ROLLESTON COAL EXPANSION PROJECT

Amendment to
Regional Interests Development Application
Glencore RPI16/RPI/001

12 September 2016

Figure 5 - Strategic Cropping Area Located within Properties

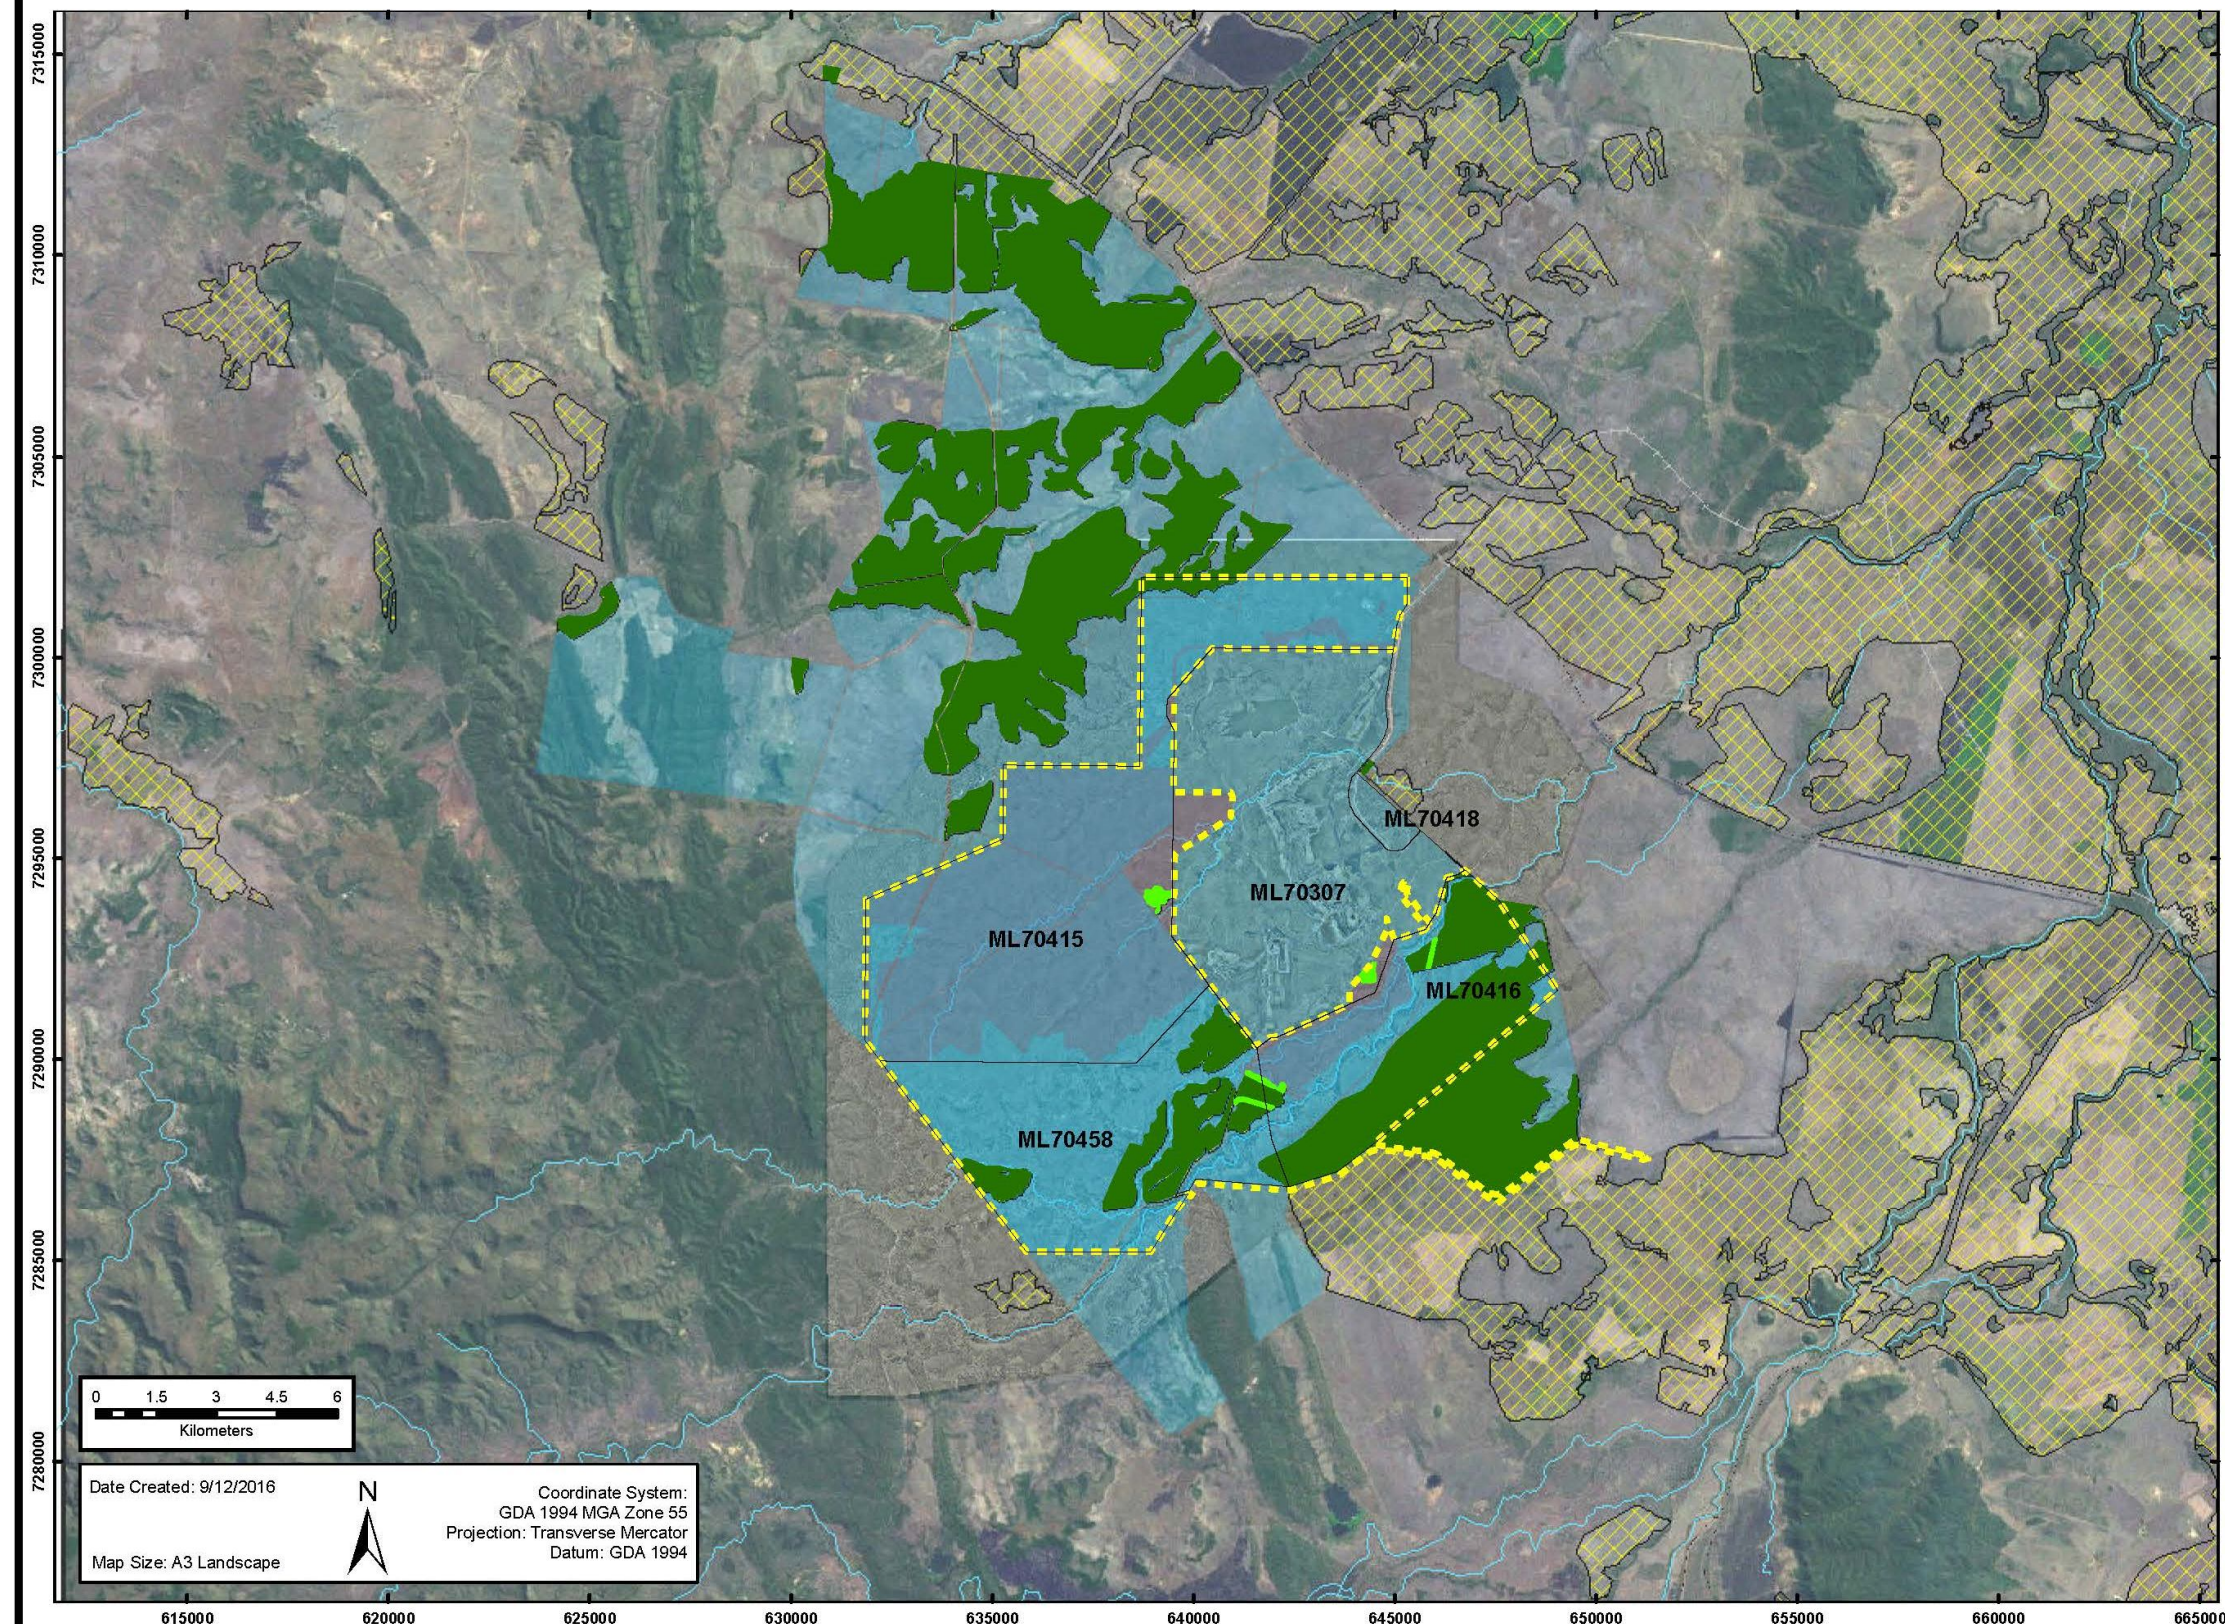
- 3.15 As noted in the April 2016 Supporting Information Report, the Applicant or Glencore own the lots of land on which the RCEP is to be carried out, and those lots form a single discrete area as they are adjacent (other than for any road or watercourse between the lots), refer Figure 5. The application involves a single 'property (SCL)' as defined in the RPI Regulation. As a result, the RCEP has been re-assessed against Required Outcome 2 for the SCA. While it remains the Applicant's interpretation that Regional Outcome 2 applies in this instance, an assessment of the RCEP against Regional Outcome 3 is again included, as **Assessment Table 3 – Strategic Cropping Land (RO3)**.
